ADDENDUM 2

ITB PW 48-19

**BLUEWATER BAY MSBU FLOOD MITIGATION PROJECT**

*This addendum addresses questions, changes bid date, and replaces pages.*

**SHEET NUMBER**  
**G3**

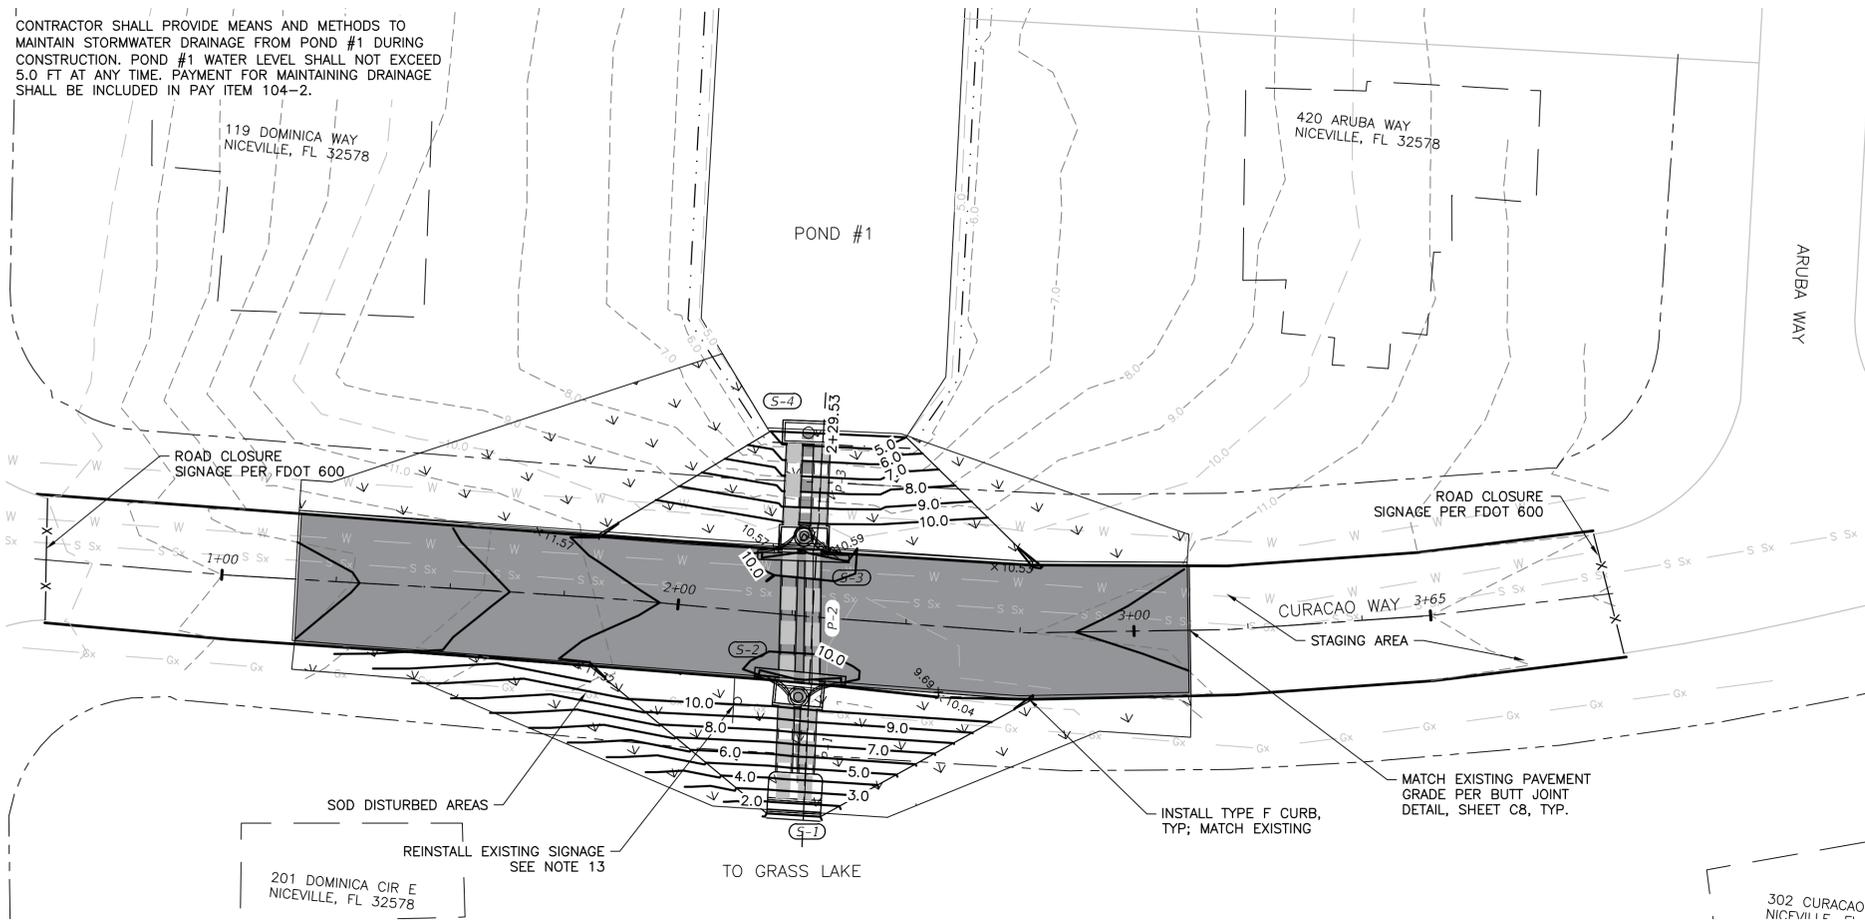
The following project drawings are revised: Sheet Number G3, Sheet Number C5, Sheet Number C5A, Sheet Number C6, Sheet Number C6A, and Sheet Number C8. Copies of the revised drawings are attached.
